WA:2544_8.109_PSC cover letter
Monday, 4 March 2019

**Re: SSD 8989 Catherine McAuley Catholic College, Medowie
Additional Information Requested to support Development Application**

Design Meeting Minutes

P0925 CMCC Access Design Analysis

Figure 1 – Intersection layout allowing for all movements in/out of Medowie Road/South Street/School Access

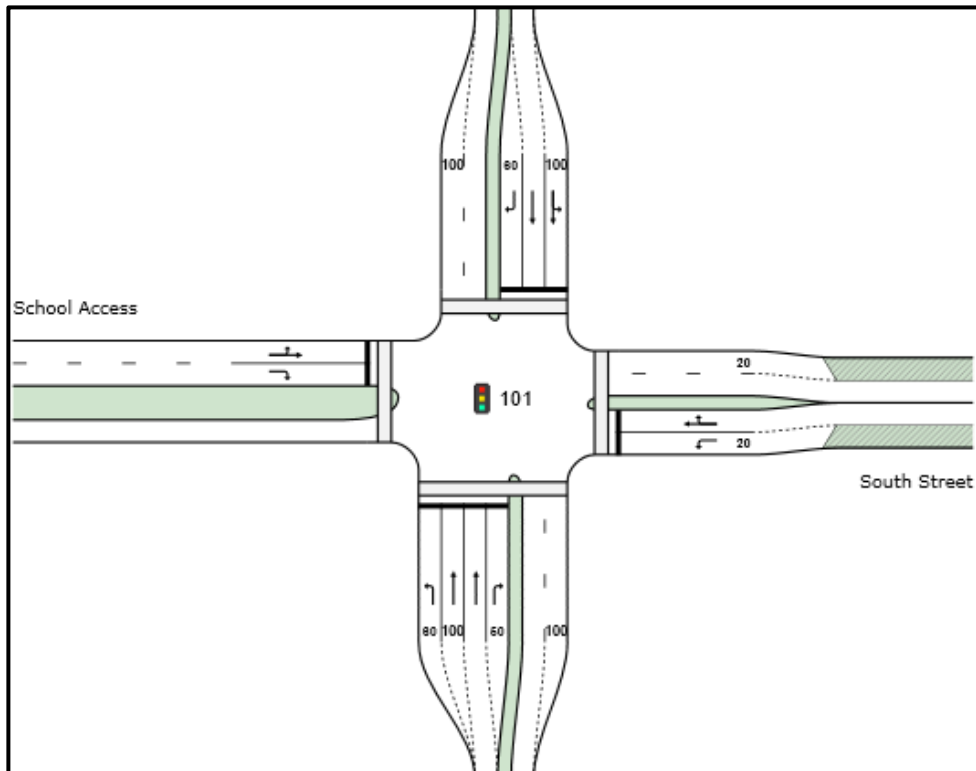
19.	JG confirms he has no further concern over the data contained in the report, and SECA's response is adequate.	Note	
20.	JG & LL notes Council's comments remain regarding the preference for all movements to the site from the intersection. However JG is sure the proposal will work and seeks a formal response to demonstrate to Council the technical aspects of the inability to get the vehicular entry & exit off the intersection, as well as the right turn into the site to work. This should be supported by modelling data. SM to prepare a response.	SECA Solutions

25.	AB suggests the options analysis and technical justification for the current design to be prepared by SECA Solutions should be incorporated into the Safety in Design Report. This should include the entire options study and not just the final outcome.	Note

As discussed above the road reserve of Medowie Road to the north of South Street provides a limited width. Allowing for design in accordance with Austroads including required lane widths, central median, cyclist considerations, as well as the future shared path along the eastern side of Medowie Road there is sufficient width to provide 5 travel lanes in total for the approach and departure on the northern leg of the intersection.

Sidra modelling determined the duplication of Medowie Road through the intersection was required in order to accommodate the traffic flows at this intersection and reduce delays and queuing to within acceptable limits. This gives a total of four lanes (2 approach/2 departure). In order to accommodate a right turn movement into the school as well as a left turn into South Street with a maximum of five lanes available the most efficient designation of vehicle movements was determined as below:

- 2 departure lanes (northbound)
- 1 channelled right turn lane into the School (southbound)
- 1 approach lane for through movements only (southbound)
- 1 combined approach lane for through and left turn movements

This layout is shown to follow in Figure 1.

Sidra modelling shows that a suitable intersection catering for all movements is not able to be provided given the constraints. Further to this, the internal site layout is unable to accommodate all entry/exit movements at a single intersection, with the cross vehicle paths leading to significant delays and congestion on site and the unacceptable result of vehicles queuing back onto Medowie Road.

DETAIL PLAN OF LOT 412
& 413 DP1063902
AT MEDOWIE
RE: 507 MEDOWIE ROAD

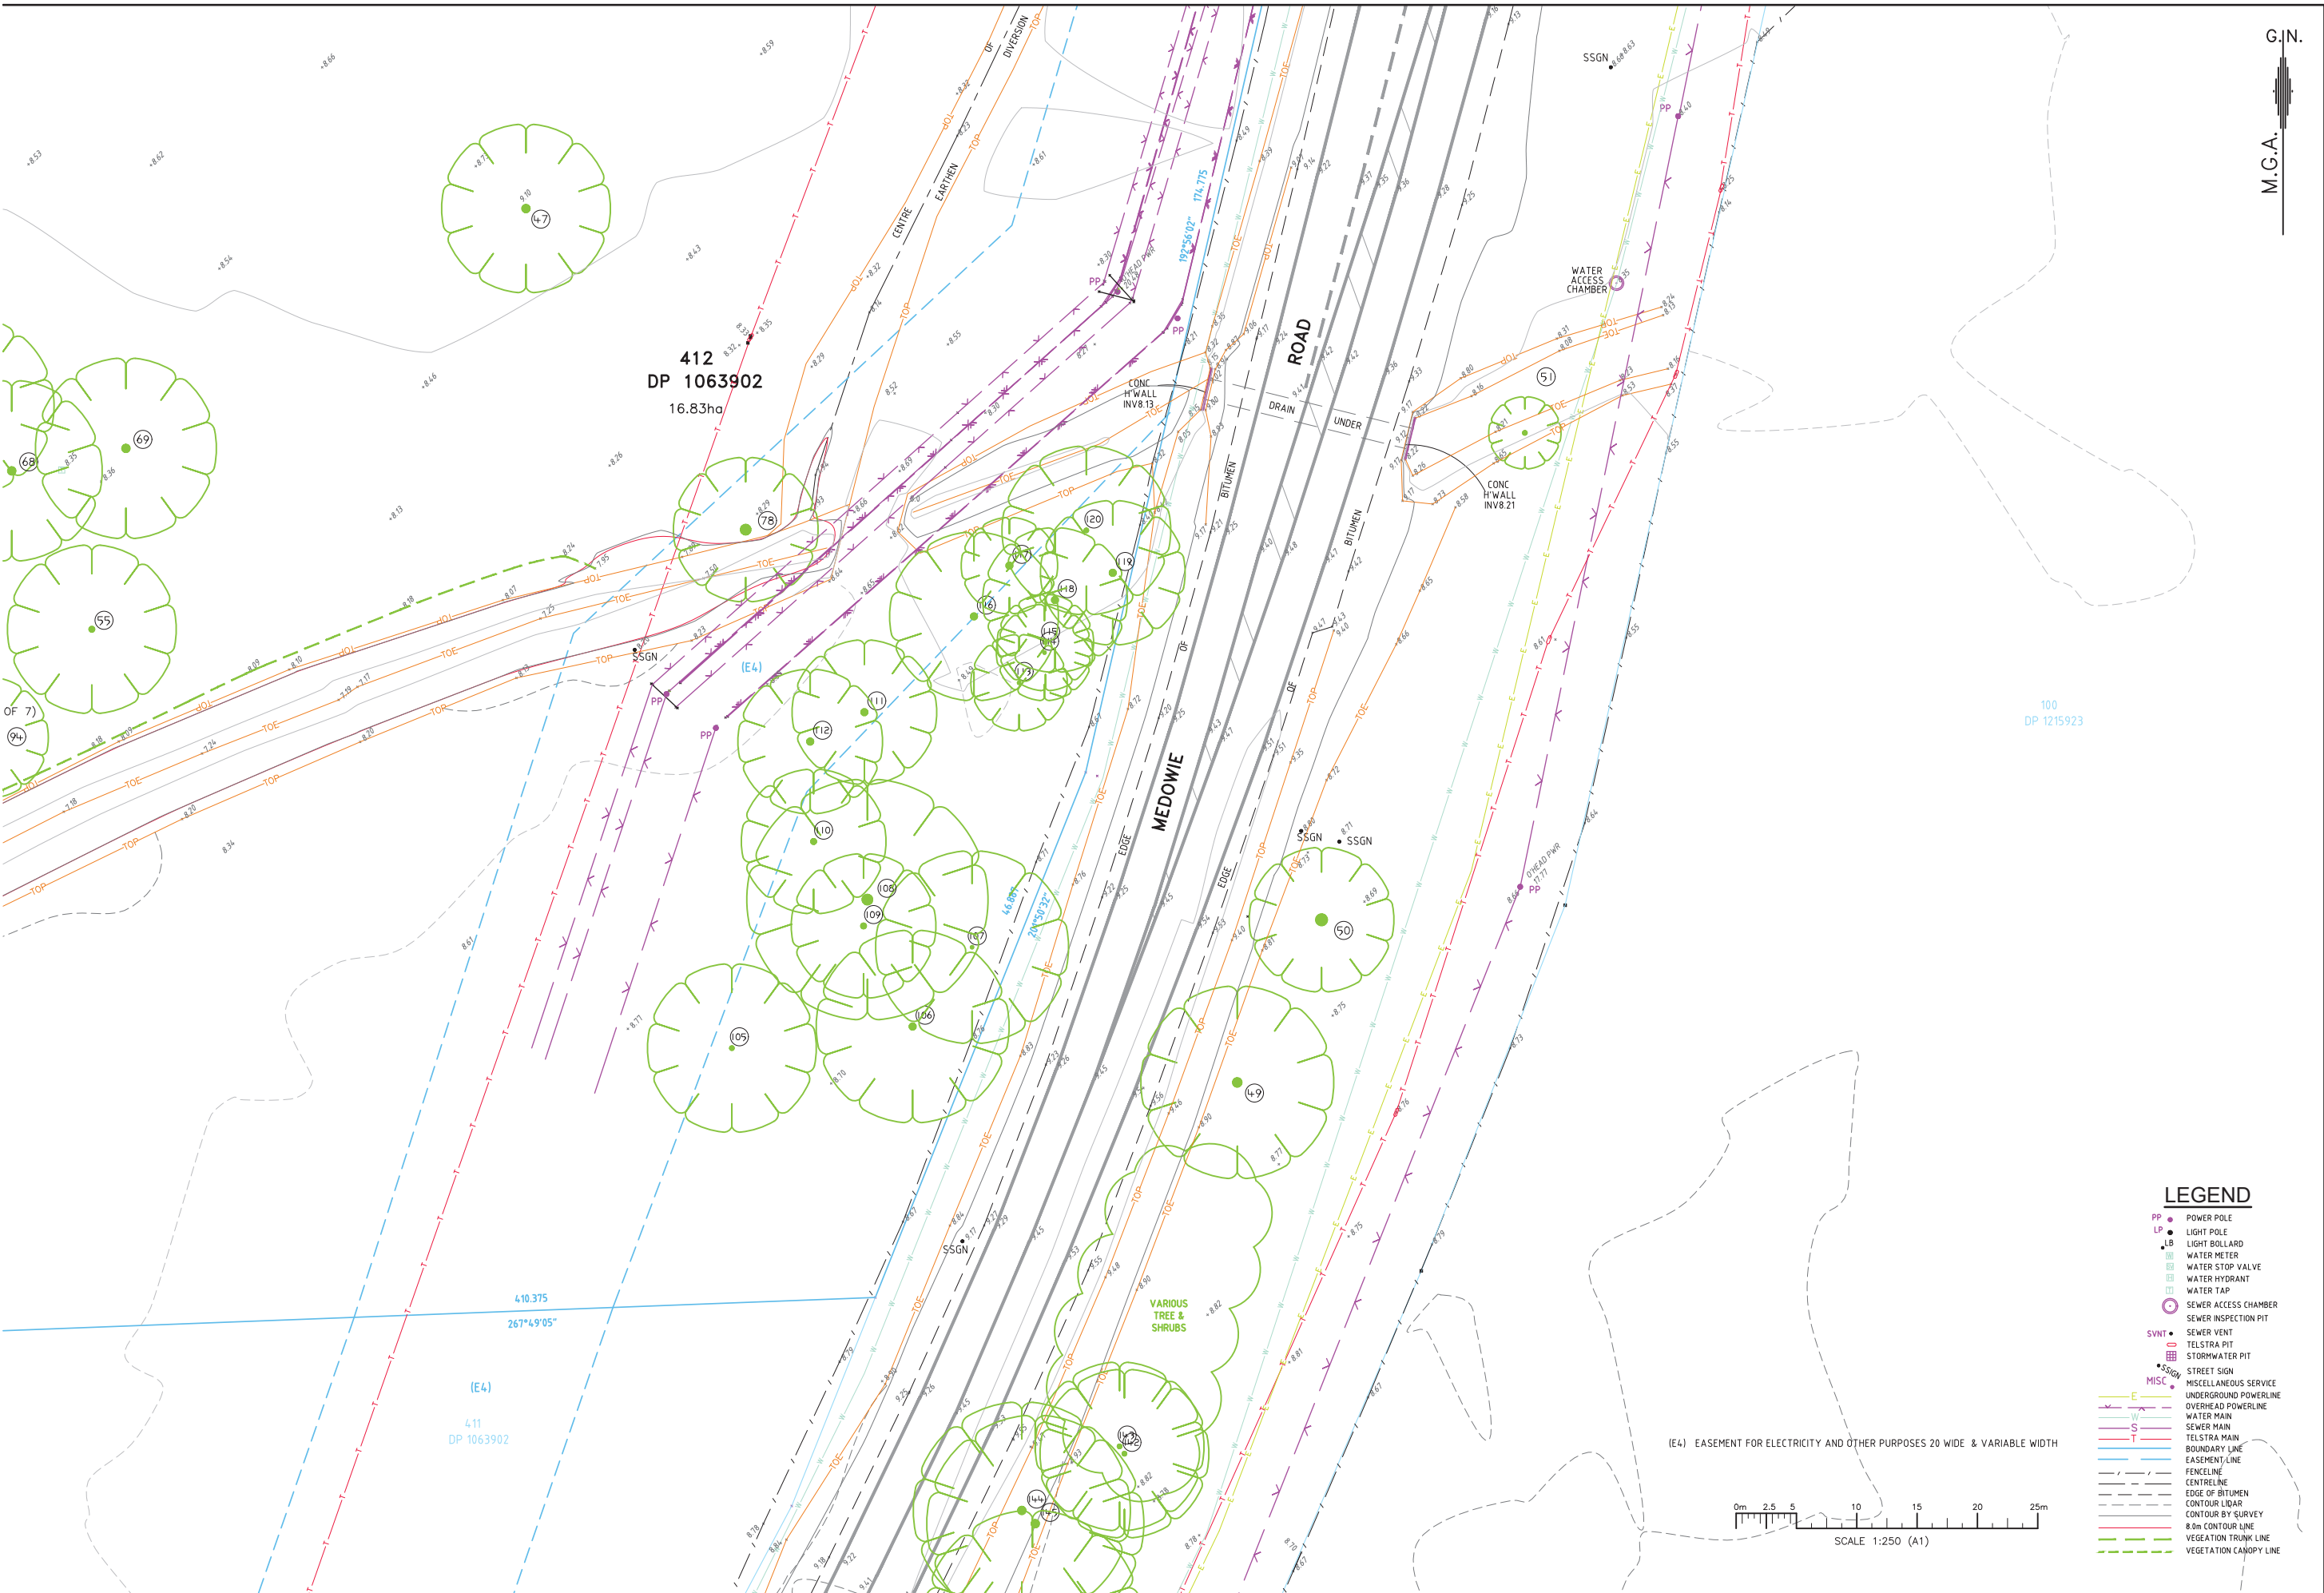
23.	JB queried why the culvert crossing under the roadway was square to the road and not tapered with the creekline to facilitate hydraulic flow. TH to request a response from the civil designer.	Webber Architects

The Civil engineer has advised the culvert shown on the concept civil roadway drawings follows the line of the existing culvert and creek bank. An extract of the site survey in this area is enclosed for reference.
